Aqueous Solutions (owner) AQS-MFG-EW_3-AUX01
EW_3 fabrication drawing AUX01 (AQS-PLAN-006 M3; graph revis
Type: fabrication drawing (GA / nozzle orientation / part sheet) Rev bb1b7216 Issued
Created: flow graph pipeline Approved: not approved (study)
Sheet 1 of 1 AQS-DWG-001

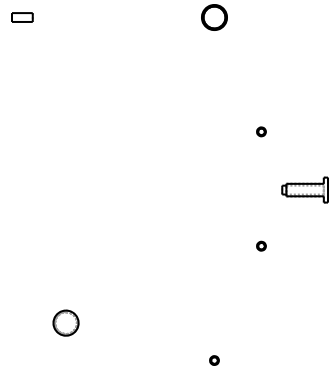
Graph revision AC - aux01: Hose barbs set in flush at the faces; barb profile a study proportion (lib/nozzles.py), finished against the hose supplier print
Graph revision AC - aux01: All process joints atmospheric hose at the face (duty section 4)
Graph revision AC - aux01: Vent support: 2 posts 30 x 30 on the inner walls + rim bridge 60 x 10 at z 750..760; dra
